Item 2 – Crossover Location and Street Trees

Figure 2 – Proposed Shared Driveway Crossover

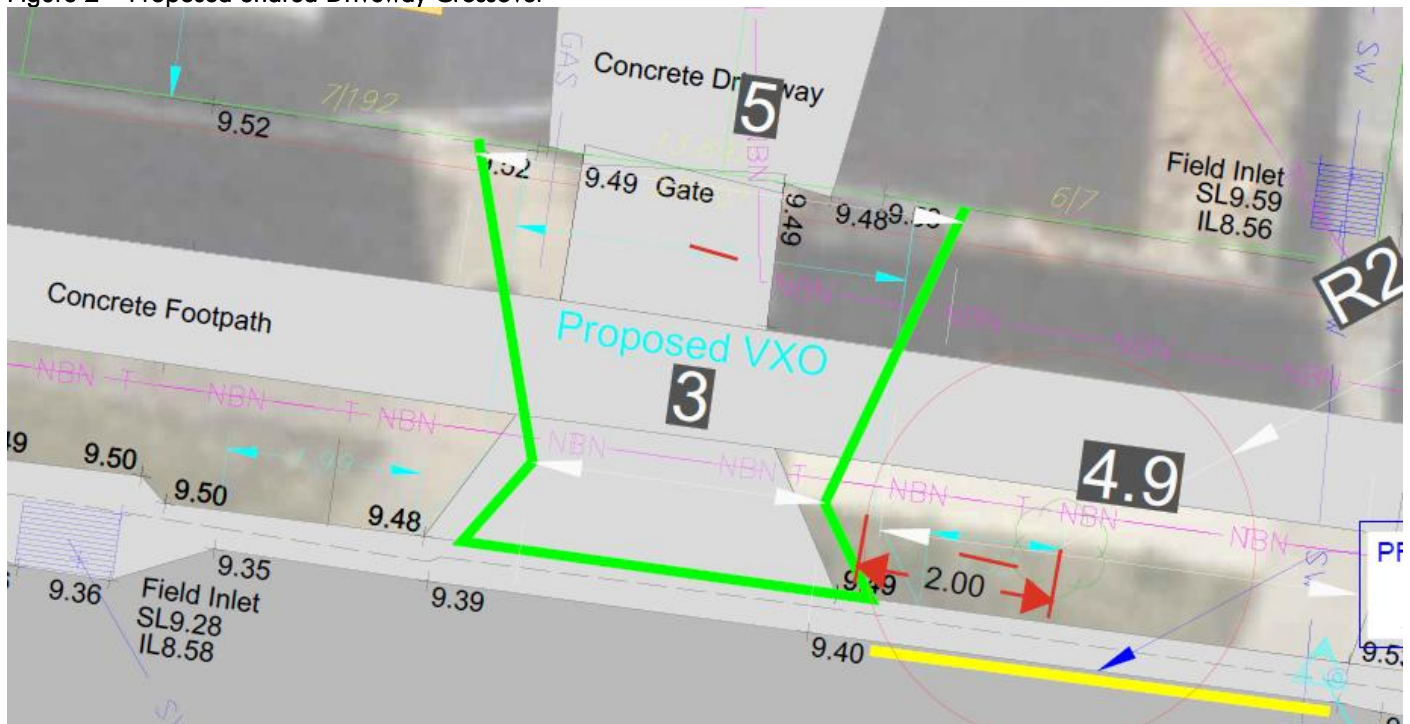
As the proposed small lot(s) has a frontage width of less than 10m, the development will need to demonstrate the proposed access, or driveway is in a location that minimise impacts to existing street tree(s) and on-street car parking required under AO27.4 of the Subdivision Code. It is noted there are on-street parking along Eliza Street.

Provide amended plans, demonstrating the location of the proposed access or driveway will minimise any impacts to existing on-street car parking and street trees.

- Demonstrate the proposed development will not adversely impact on the on-street car parking on Eliza St. Provide RPEQ justification against any performance outcomes sought.
- It is noted that an existing street tree is situated along the Eliza Street frontage within the Council verge. The proposed driveway appears to conflict with the existing street tree. Provide an amended site plan accurately depicting the location of the existing street tree(s), with dimensions and distances measuring from proposed driveway edge. Note: The driveway and its splays must be positioned at a minimum distance of 2m from the trunk of a cylindrical street tree, or 5m from the trunk of a buttress street tree.

A revised shared vehicle crossover is proposed to service proposed Lots 10 and 11. The crossover has been designed with a width of 3m at the kerb, excluding the apron tapers, before widening to 5m at the property boundary. This arrangement is consistent with the amended crossover configuration contemplated by proposed AO31.2 of the *More Homes, Sooner – Low-Medium Density Residential Design* amendment and the corresponding future Sheet 2 of Standard Drawing BSD-2022. While these provisions are not yet operative assessment benchmarks, they provide contemporary design guidance for a shared driveway servicing two small LMR lots. The revised arrangement has been designed to minimise disruption to the Eliza Street verge and kerbside frontage as far as practicable.

The crossover location and configuration have been reviewed by Modus Transport and Traffic Engineering (RPEQ). Their assessment confirms that the proposed access:

- provides functional shared access to both proposed allotments;
- limits the crossover to the minimum practical width at the kerb;
- retains approximately 5m of kerb length to the west and approximately 4.9m between the crossover and the existing driveway at 6 Eliza Street; and
- represents the arrangement that best balances access functionality, street tree retention and the preservation of on-street parking opportunities.

While the crossover will alter the continuous kerb length presently available along the frontage, its location and configuration minimise this impact to the greatest practicable extent. Please refer to the attached Traffic Engineering Response for further detail.

The revised design achieves a minimum separation of 2m between the outside face of the existing cylindrical street tree trunk and the closest part of the proposed crossover, including its splays. The proposal therefore complies with Council's nominated street tree separation requirement, and no removal or relocation of the tree is proposed. The existing street tree is also juvenile and has a comparatively limited trunk and root spread, which further reduces the potential for conflict during construction. Notwithstanding this, the proposal does not rely on a reduced separation from the tree.
